**From:** Charlene Land <csland@garlic.com>  
**Sent:** Wednesday, March 24, 2021 11:47 AM  
**To:** Ian Land <iland\_7@yahoo.com>  
**Cc:** Sean Mullin <SMullin@losgatosca.gov>; IAN LAND <iland8@icloud.com>  
**Subject:** Re: submission for 140 Arroyo Grande Way

**Subject:** APN 424-23-048 - 140 Arroyo Grande Way

RE: Response to concerns raised by adjacent neighbors

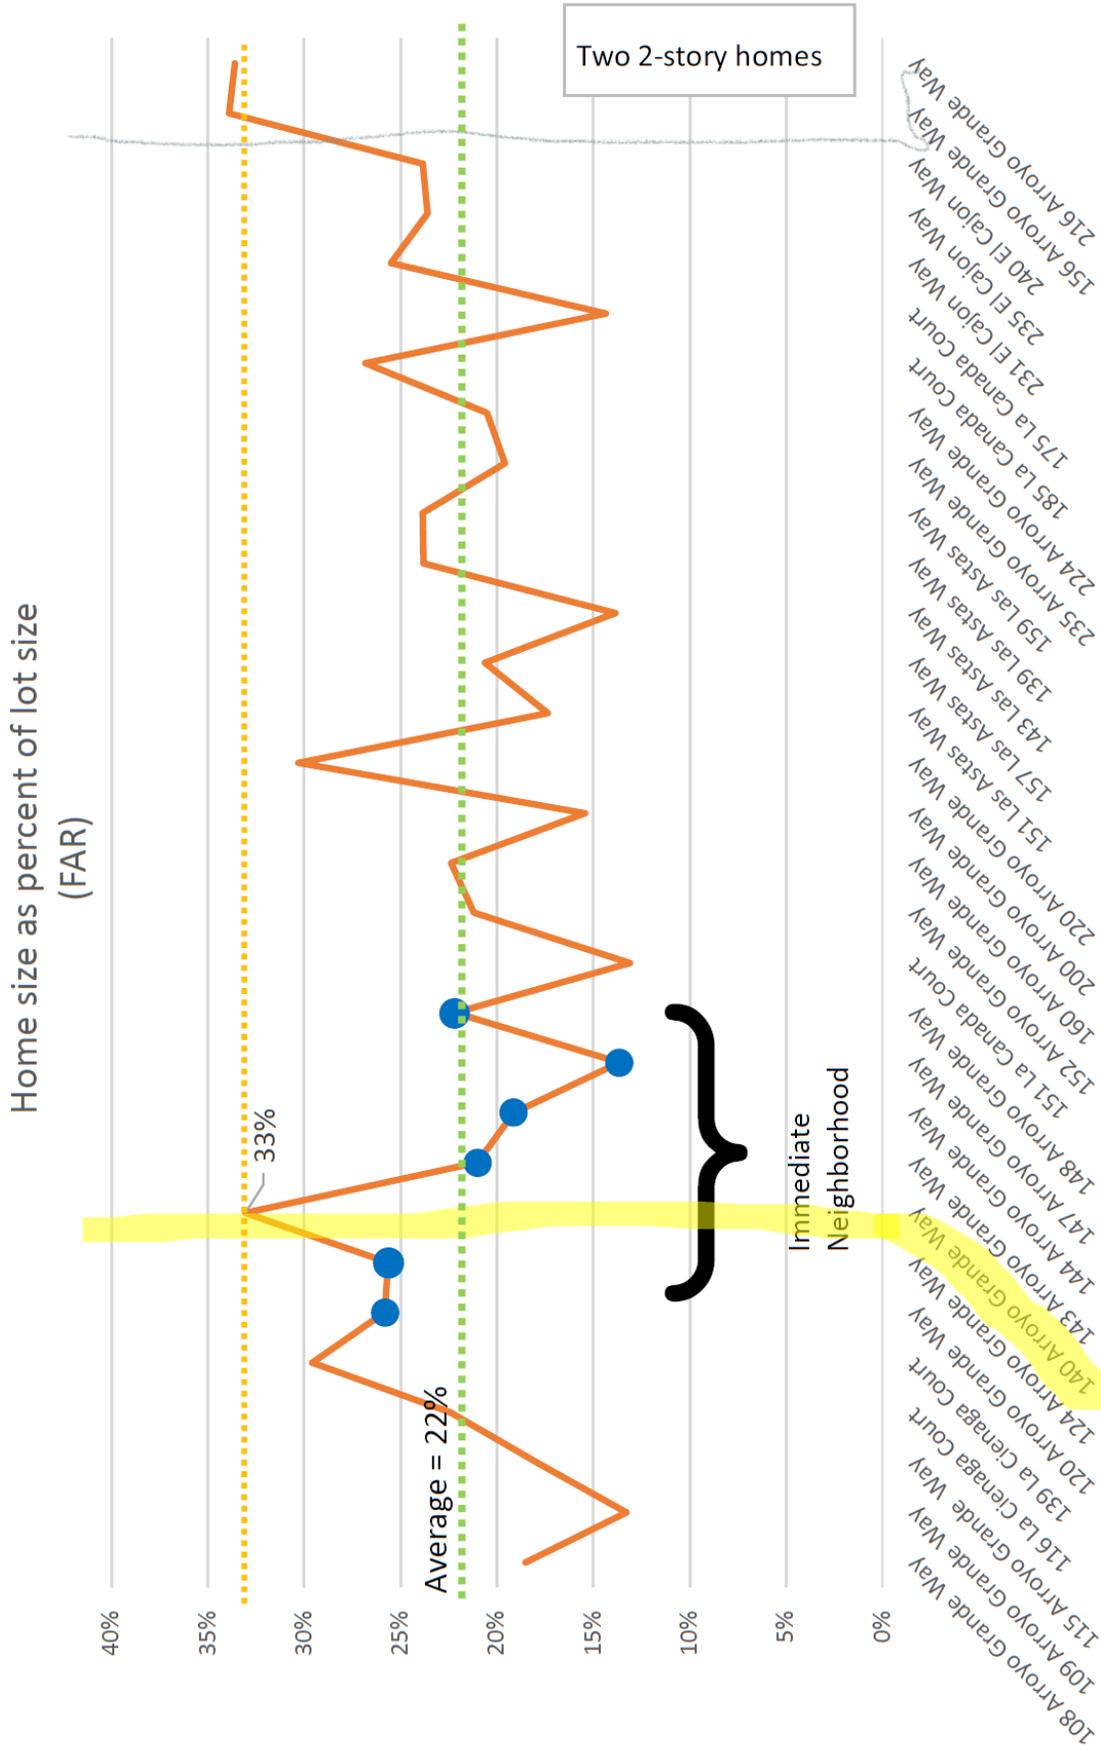
The FAR of the proposed construction is 33% (versus incorrect 40%).

Please note that 33% FAR exceeds all other single-story homes in the 30 nearest subdivision homes used in our chart, the average of which is 21% for interior parcels.

For the seven homes in the immediate neighborhood of the proposed construction, the average FAR for internal parcels is 23%.

In addition to updating the chart with the project's actual FAR, the relevant "immediate neighborhood" homes are now marked. Please see the attached updated chart.

DATE	
DRAWN	
CHECKED	
SCALE	
TITLE BLOCK	
SHEET	
<b>A5</b>	
OF	
SHEETS

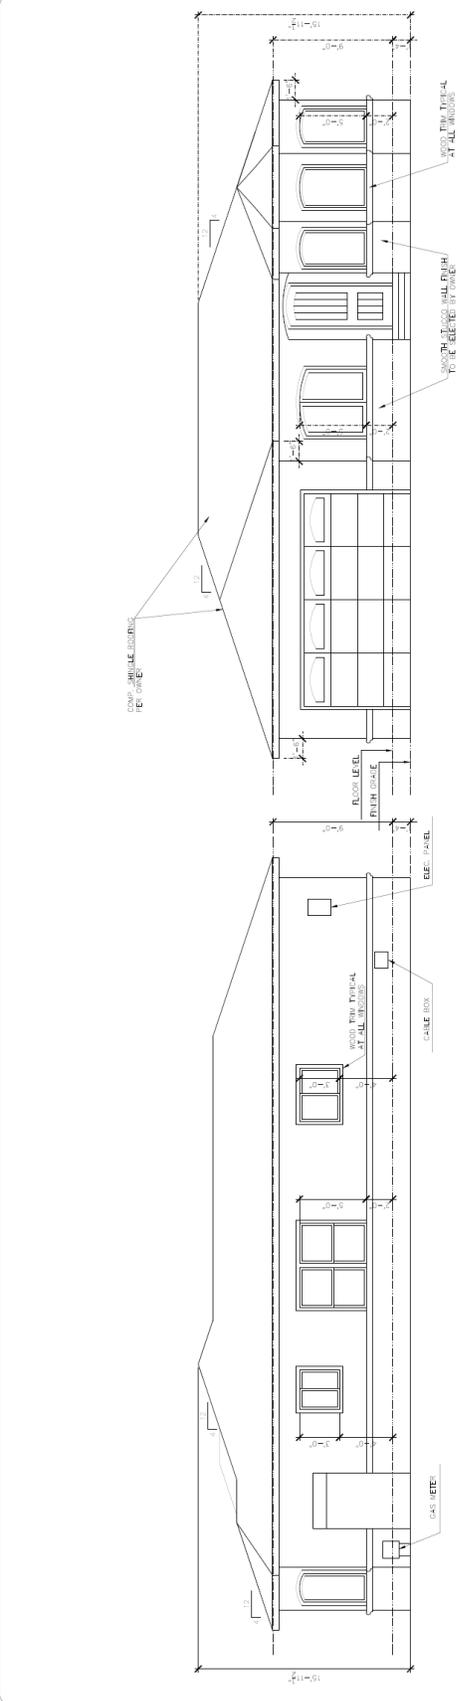
Changes should be reflected in the storyboards before the May 12<sup>th</sup> Planning Commission hearing

We believe our privacy will be better if you replace the turret and conical roof section with a bay window and hip roof

Please find attached the revised elevations based on the planning commission review feedback. We have lowered the exterior walls from 10' to 9'. The roof design and pitch has also been updated to decrease the overall height of the proposed home by 6'. We believe that these changes should address your sky-view and privacy concerns. Let us know if you have any other comments or suggestions.

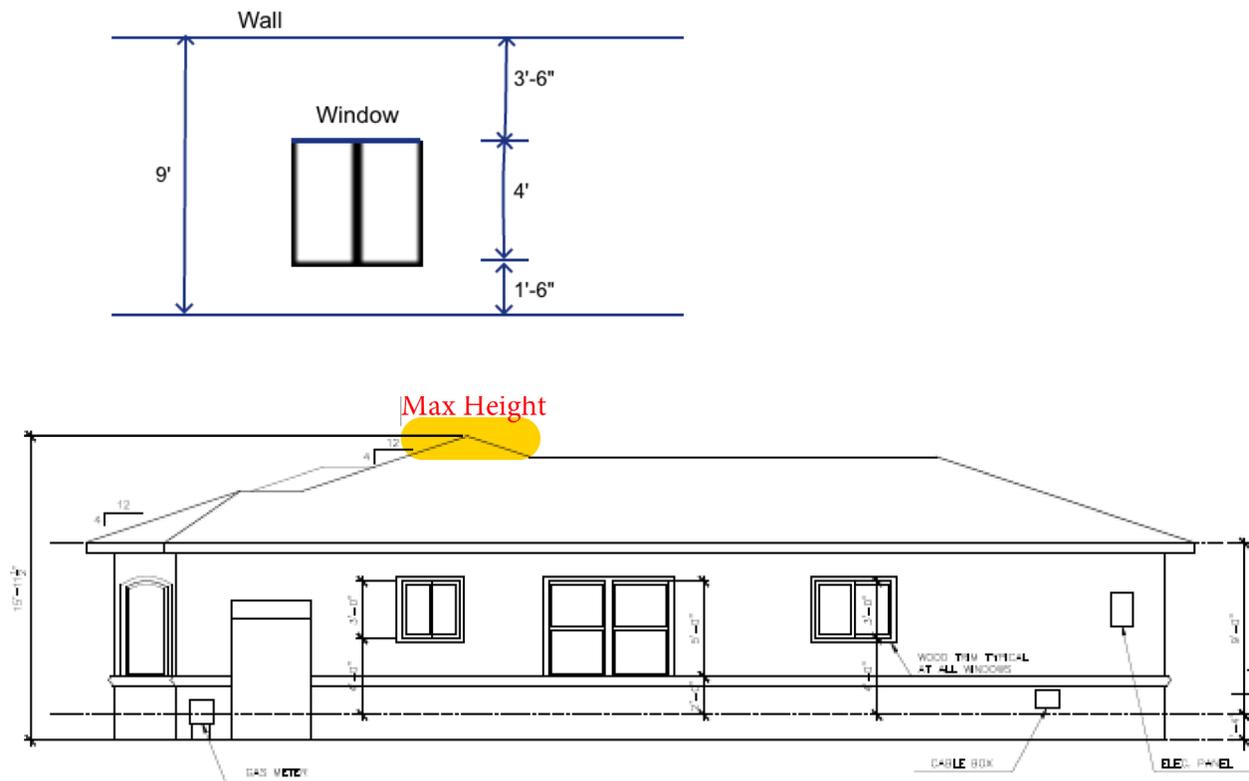
*"Lower windows - we appreciate your reducing your windows, but the fence and our top-down/bottom-up blinds mitigate our privacy concerns if you would like to raise the windows back up."*

The bedroom window on our side elevation towards your home does not align with any of your windows. The remaining two windows are bathroom windows, which will have no visibility. We have attached an image that indicates how a 4' window would look with the top of the window at 5'-6" from floor level to be aligned with the top of the fence at 7'. As you can see, this results in the window being too low on the wall. We hope you can understand that we value your privacy and that there is no way for us to look over the fence standing at the floor level.
